7 World Trade Center

Project No.5576A

RFI LOG

MAYORS OFFICE OF EMERGENCY MANAGEMENT

1/8" = 1'-0" FSK-5

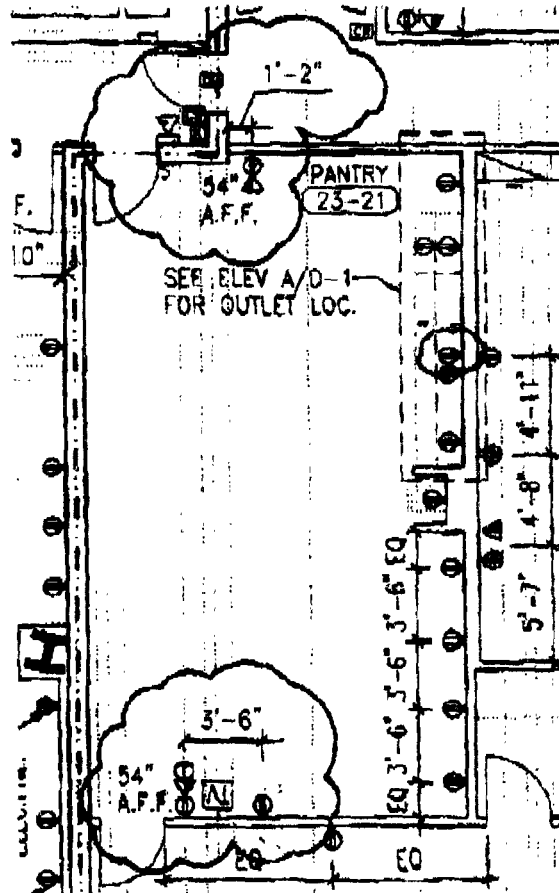
RM #23-21 PTE CLARIFICATION
